**PETITION FOR VARIANCE APPLICATION**

RE: Madison Municipal Building Fire Smoke Damper Control – Variance; MEP Project No.: M10.15.02

## City of Madison Fire Department Position Statement

Sheet: AHU-3 SA  
Issue: Variance Request  
Date: 2018.06.20  
Project #: M10.15.02

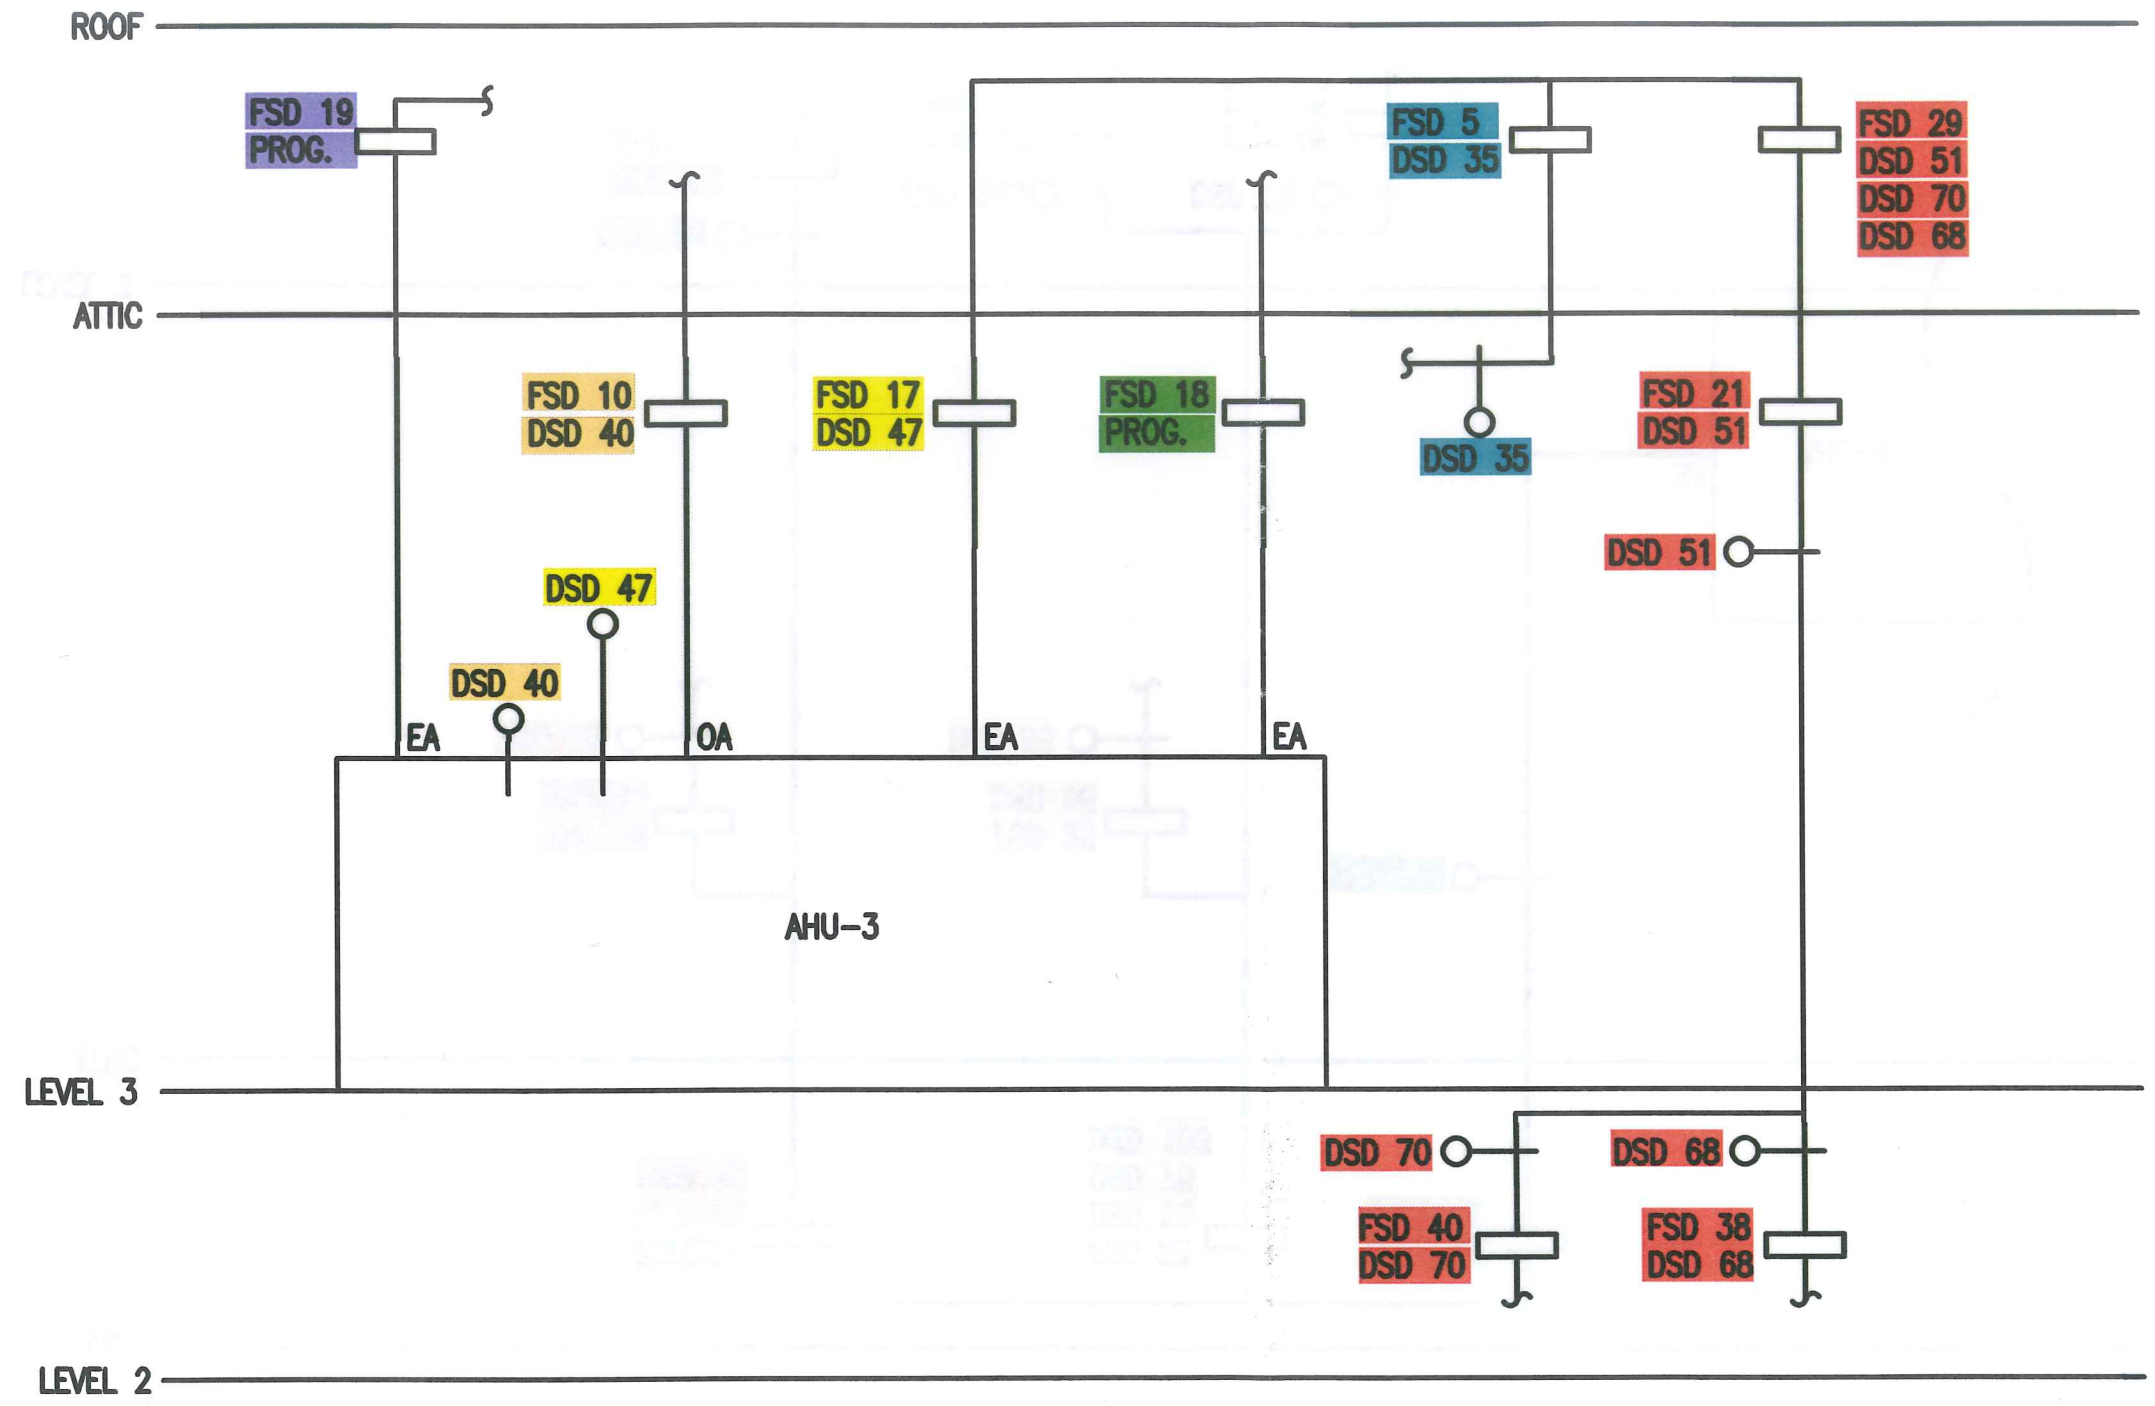
1. AHU-3 Supply Air FSD-30 being controlled by the same signal as FSD-37/DSD67.
2. AHU-3 Return Air FSD-28 being controlled by the same signal as FSD-39/DSD69.
3. AHU-4 Return Air FSD-35 being controlled by the same signal as FSD-47/DSD77.

1. AHU-3 Supply Air FSD-32 shall close if either FSD-41/DSD71, FSD-42/DSD72, or FSD-22/DSD52 are closed.
2. AHU-3 Return Air FSD-31 shall close if either FSD-43/DSD73, FSD-72/DSD102, or FSD-23/DSD53 are closed.
3. AHU3 Exhaust Air FSD-29 shall close if either FSD-40/DSD70, FSD-38/DSD68, or FSD-21/51 are closed.
4. AHU-4 Supply Air FSD-33 shall close if either FSD-73/DSD103, FSD-45/DSD75, or FSD-25/DSD55 are closed.
5. AHU-4 Supply Air FSD-36 shall close if either FSD-46/DSD76 or FSD-26/DSD56 are closed.
6. AHU-4 Return Air FSD-71 shall close if either FSD-44/DSD74 or FSD-24/DSD54 are closed.
7. AHU-4 Exhaust Air FSD-34 shall close if either FSD-48/DSD78 or FSD-27/DSD57 are closed.

- Duct detectors and their placement shall comply with NFPA 90A & NFPA 72,
- A minimum of (1) duct detector shall be installed for each smoke damper unless allowed by NFPA 90A.
- MFD will support distances greater than 5-ft where installation/access is difficult within reason provided all other elements of the fire/smoke dampers and the location of inlets/outlets conform to the IMC, NFPA 90A & NFPA 72.
